APPENDIX B
POST-DR II DESIGN CHANGES

Oregon Square
November 5, 2015

CAMPUS COMMENTS TO ADDRESS - POST DR II

CURRENT - BL 91 GROUND FLOOR

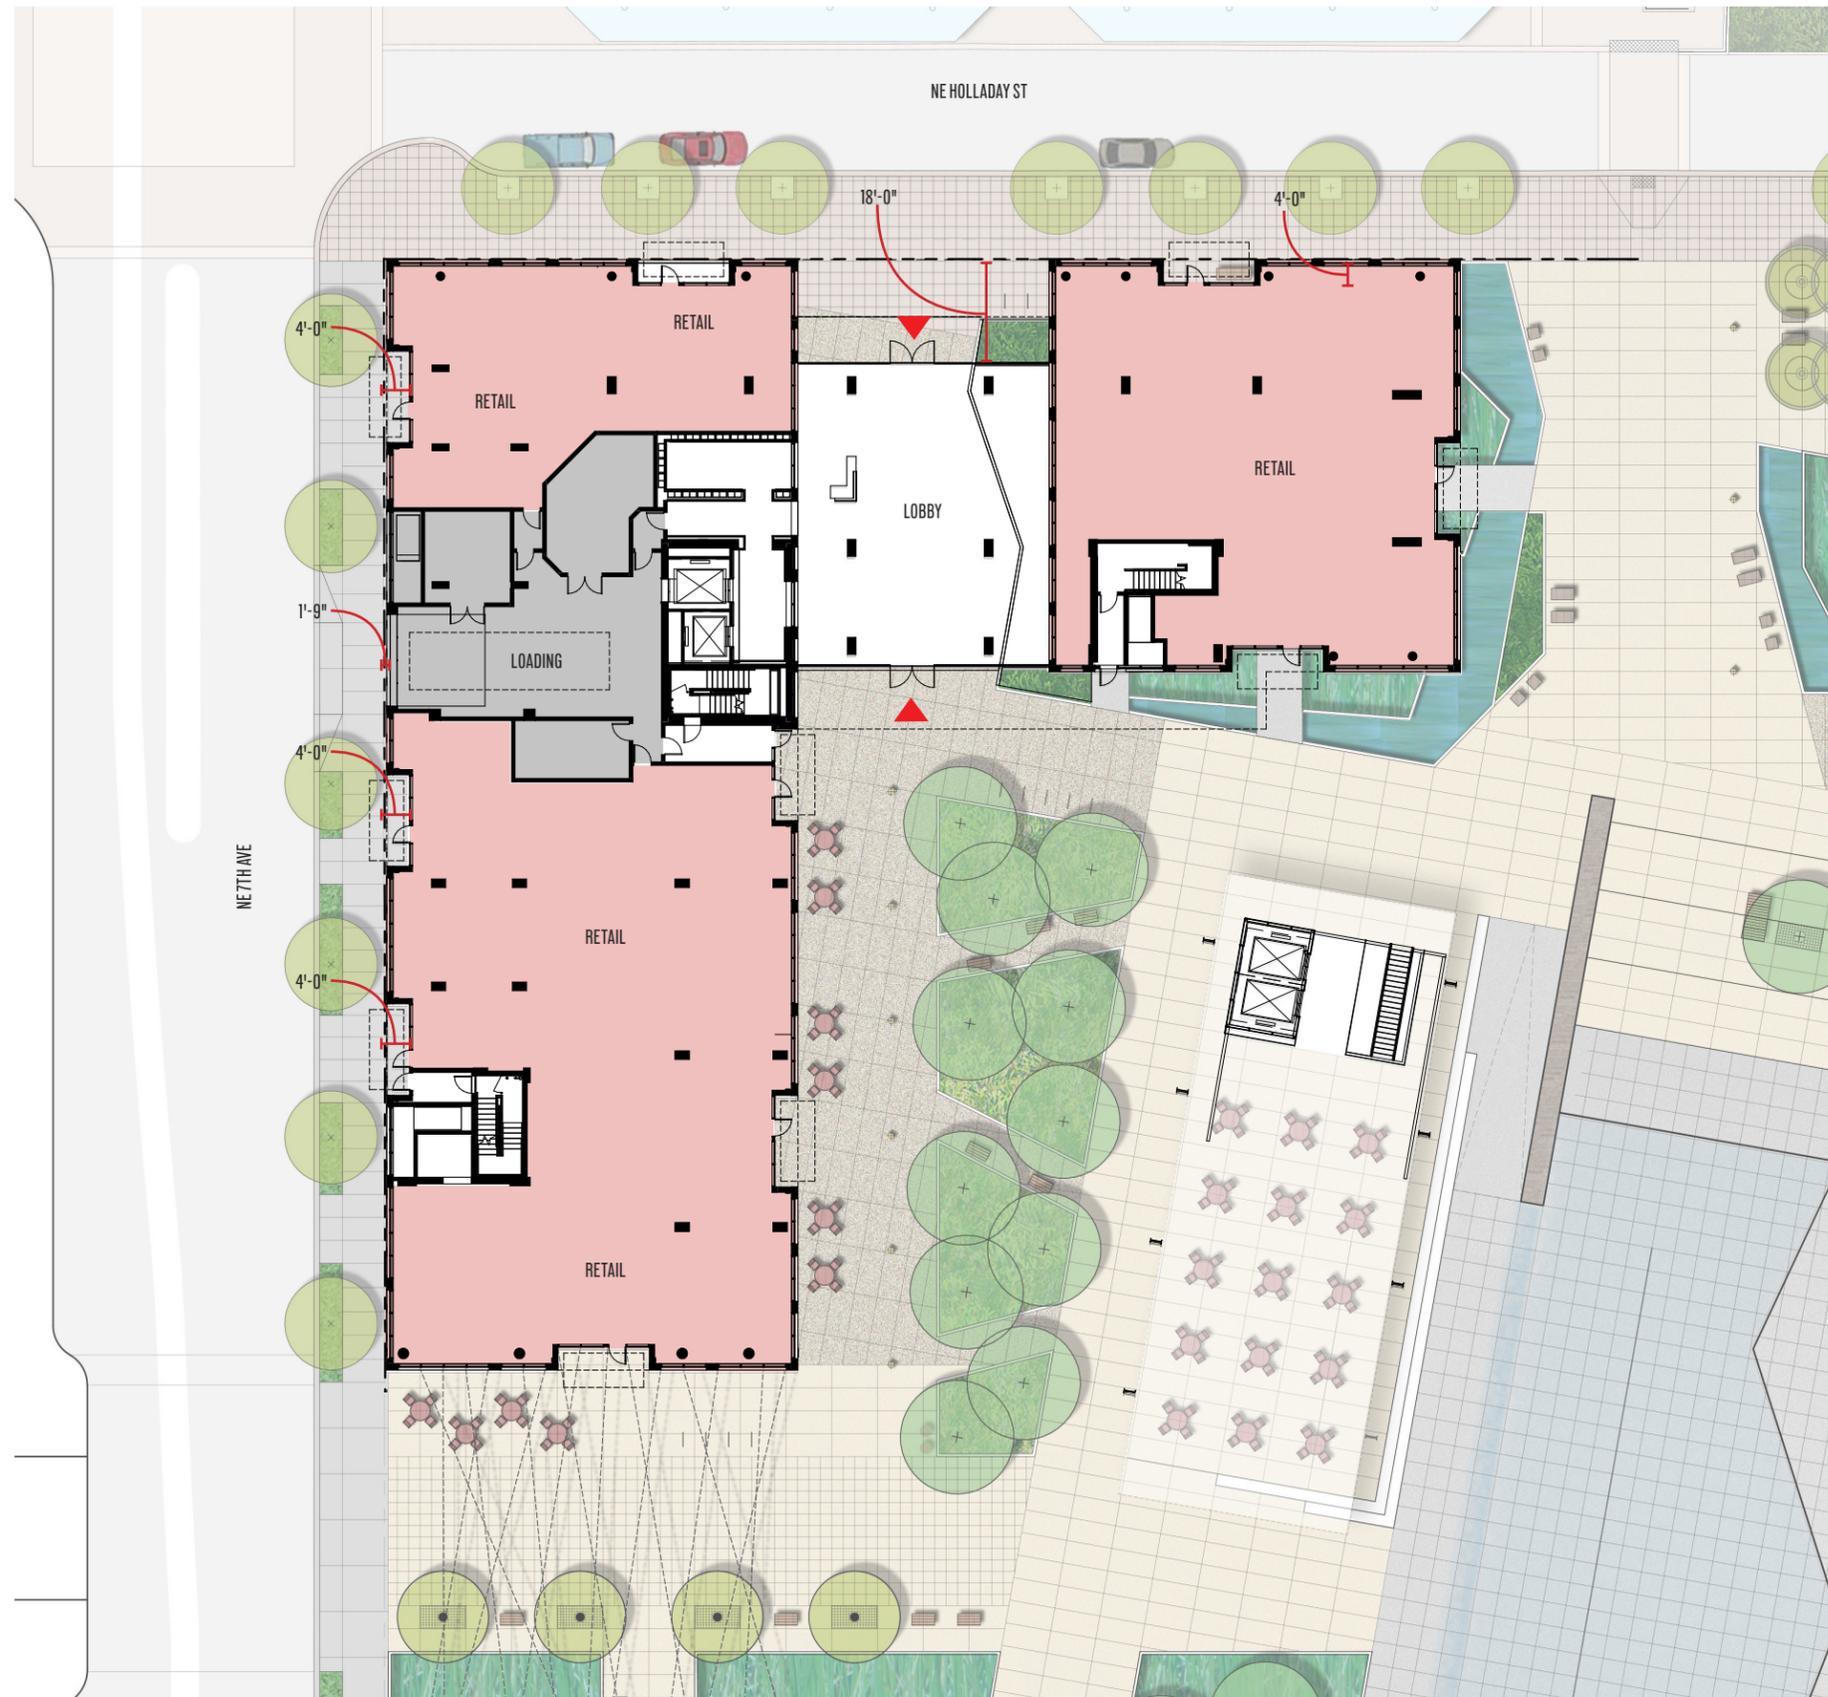
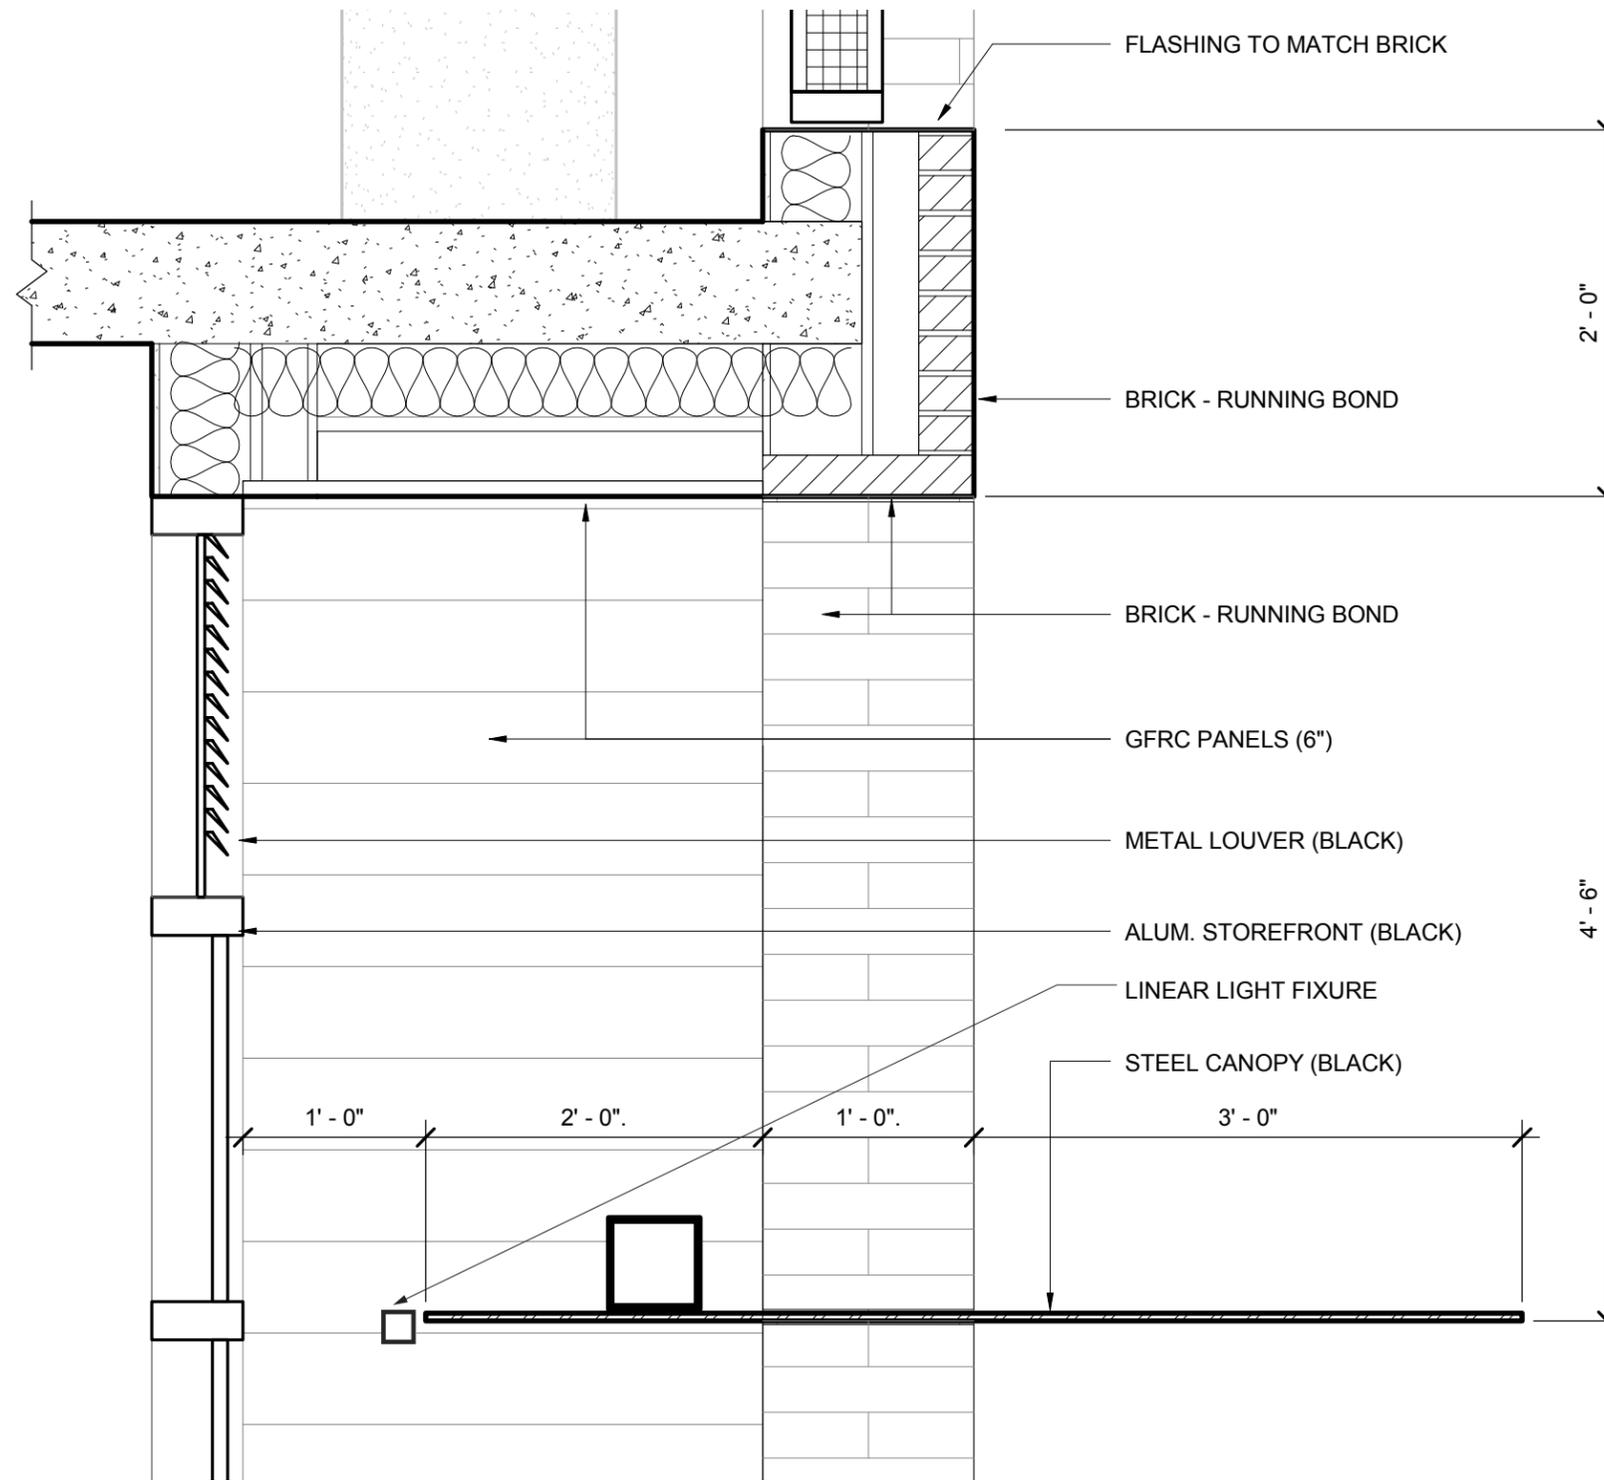
Lobby preferred in pass-thru space. If retail expands when lobby relocated, add an entry with a canopy along North facade to retail space. One preference for revised pass-thru space.

GBD: Will provide like alcove and entry. Confirmed - not pursuing continuous canopy coverage.

CURRENT - BL. 102 GROUND FLOOR

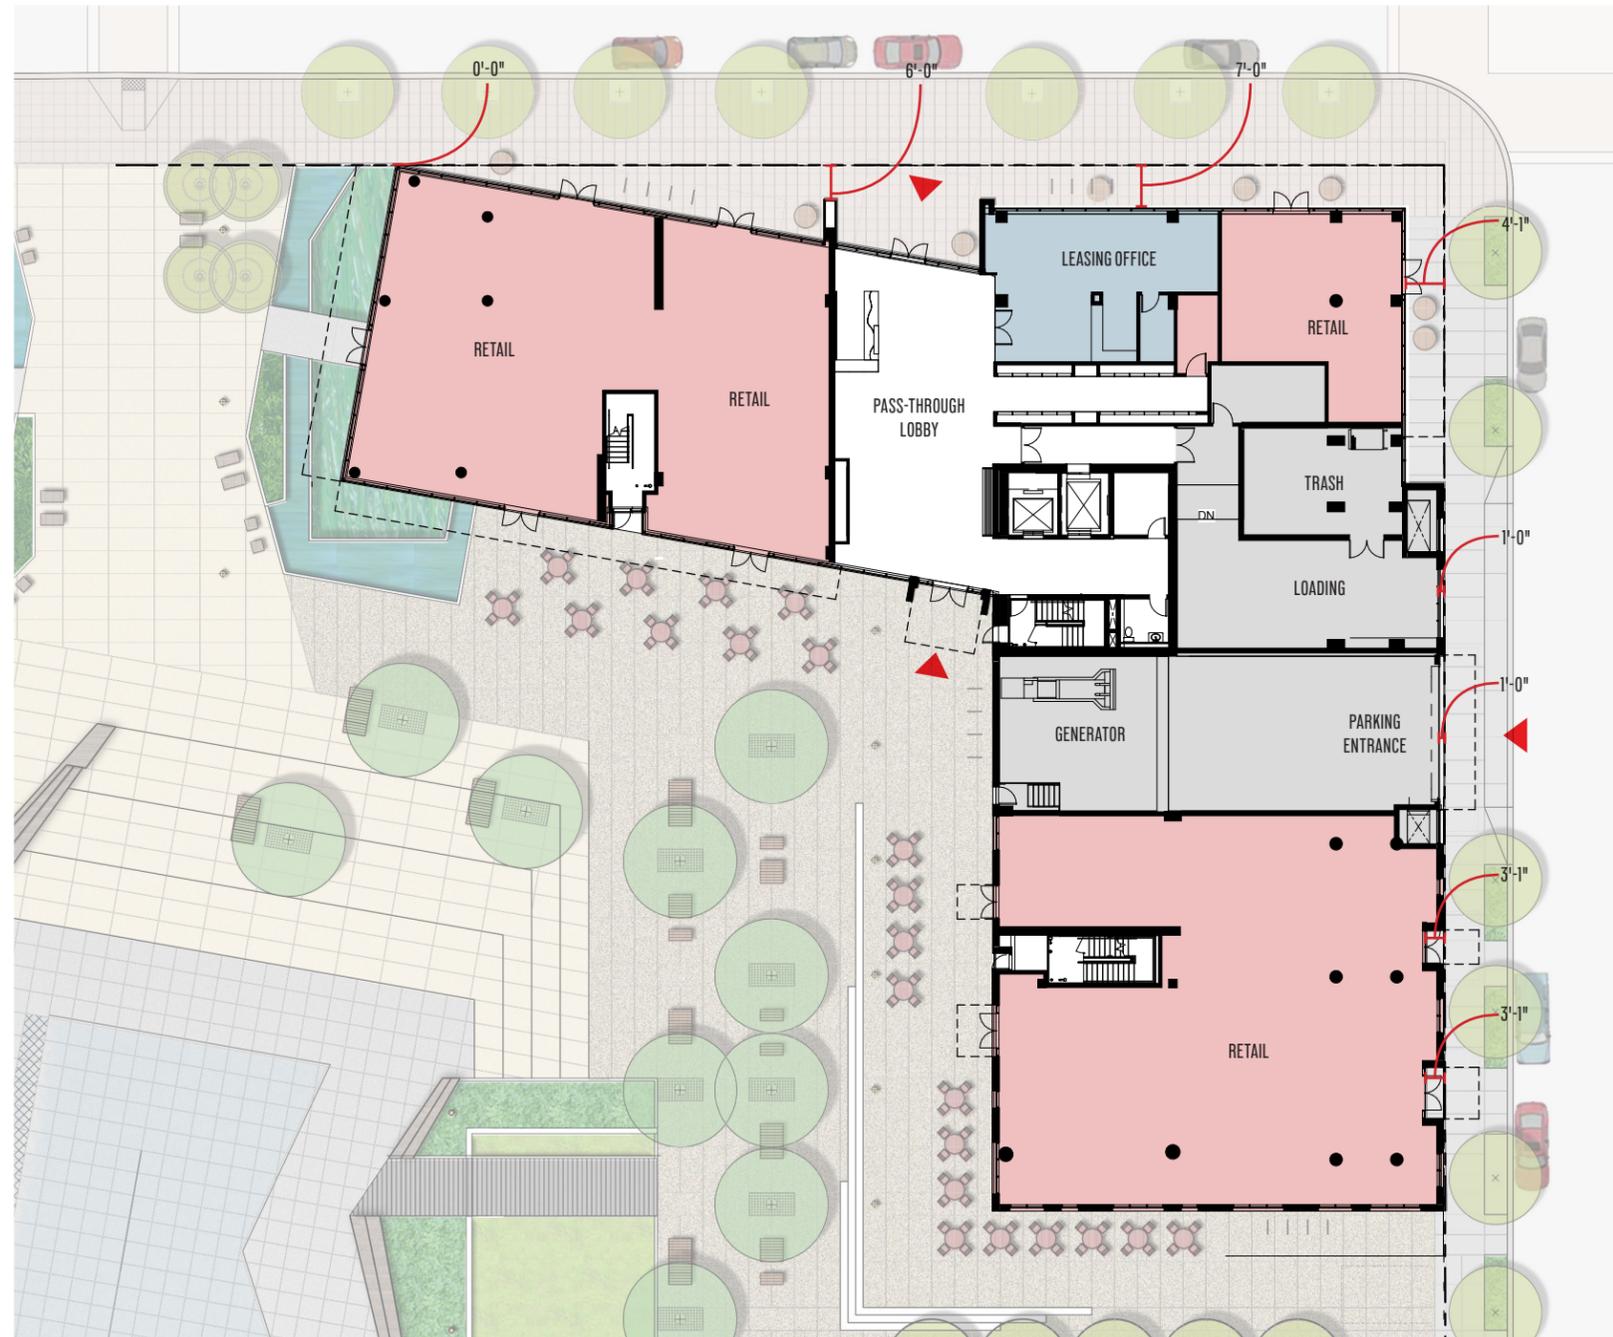
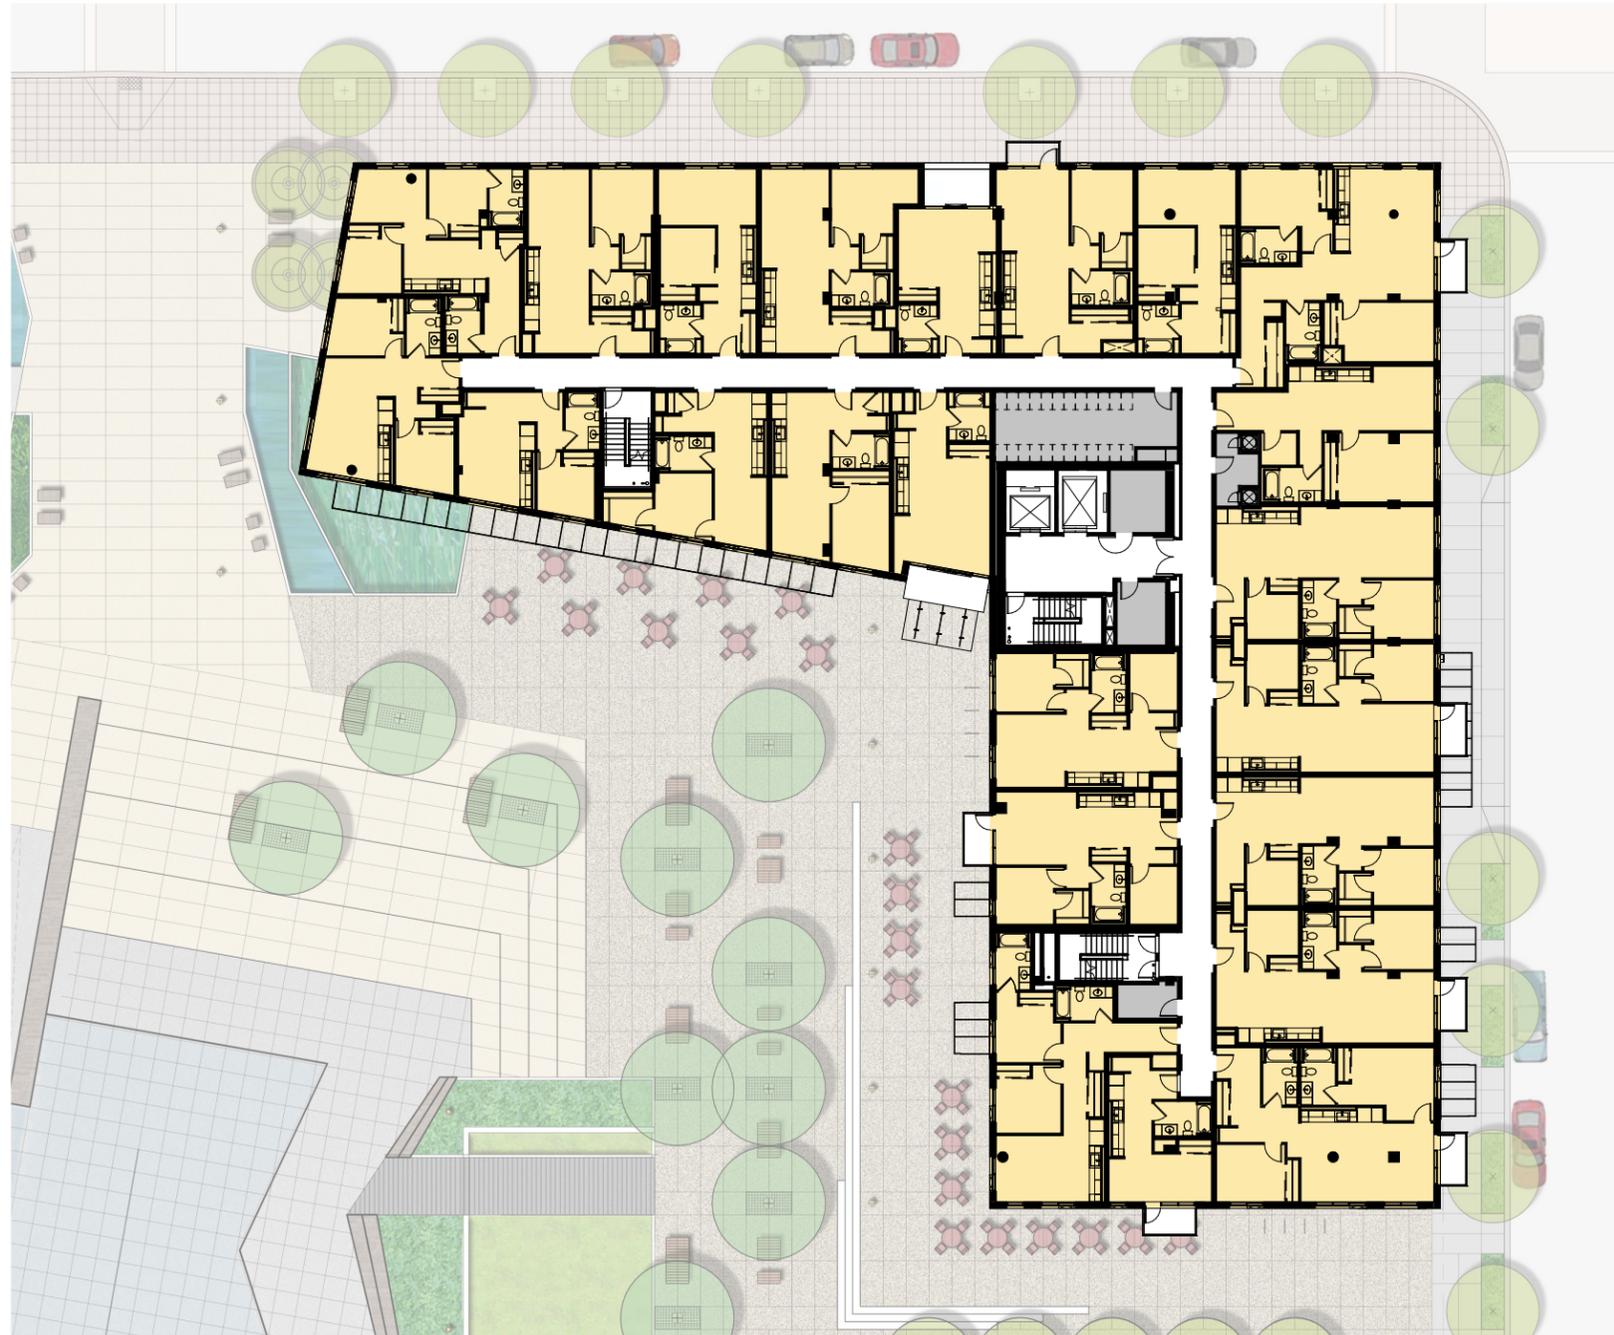
On North side ground level parallel with property line preferred, but set back ground floor same distance to match Southeast corner. Ok if lobby is setback further. Address structural column West of lobby so it is not outboard of the wall.

GBD: Should work nicely - we will bring this study/direction with us.

GARAGE ENTRY WALL GRAPHIC CONCEPTS

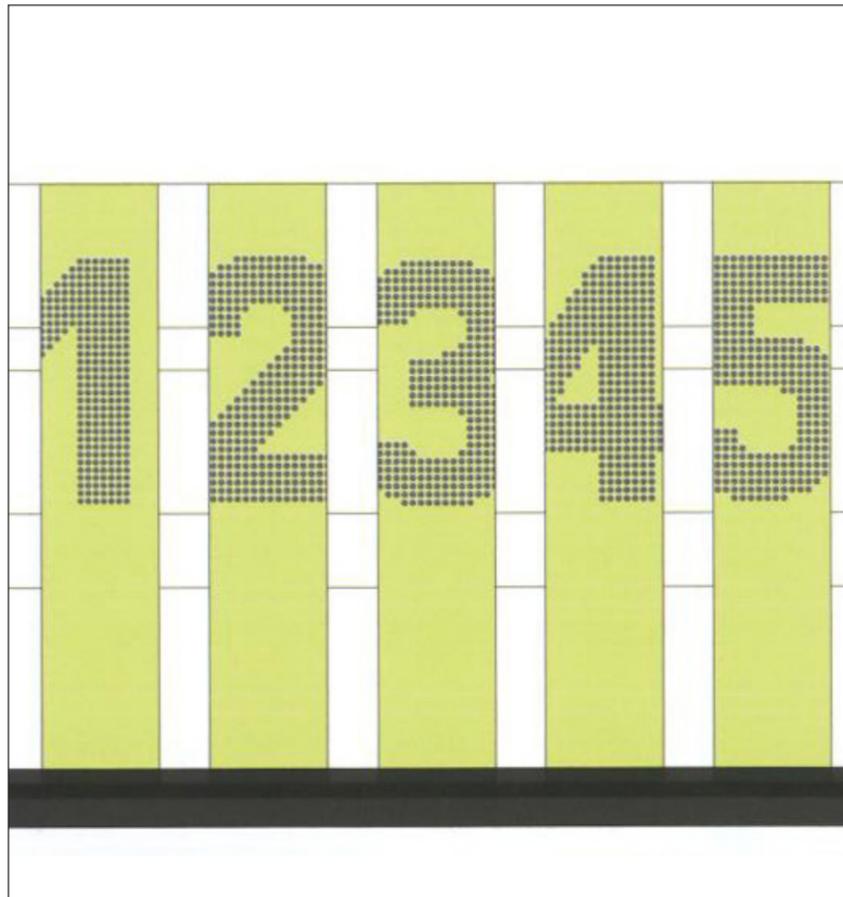
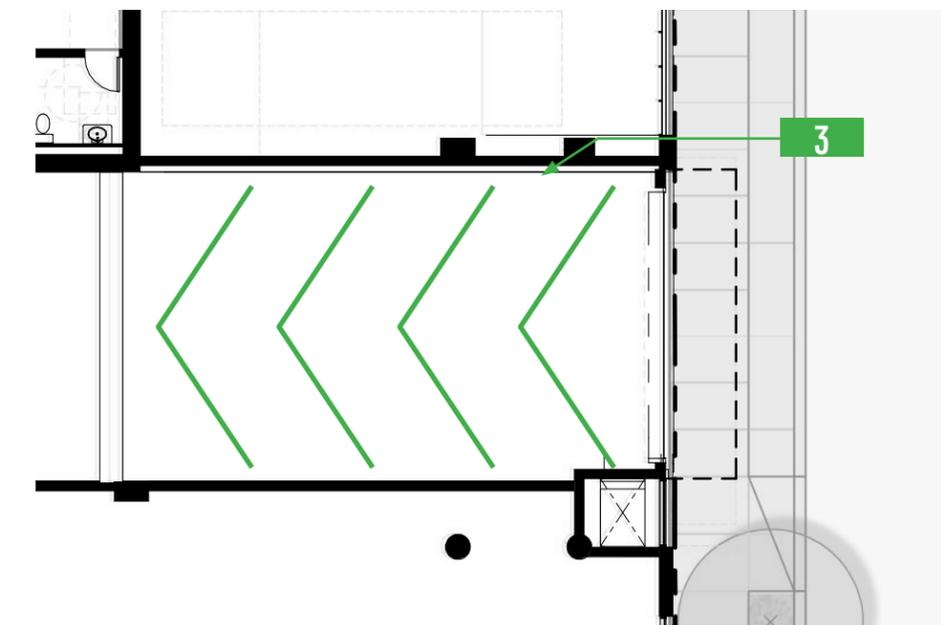
Provide elevations of interior walls of both garage entries to show lights and graphics.

This imagery represents the design intent for the graphics and signage on the garage entry walls. These are similar to what was used in phase 1 (Hassalo on eighth); We do not want to be held to these specific graphics, but rather the intent shown in this imagery.
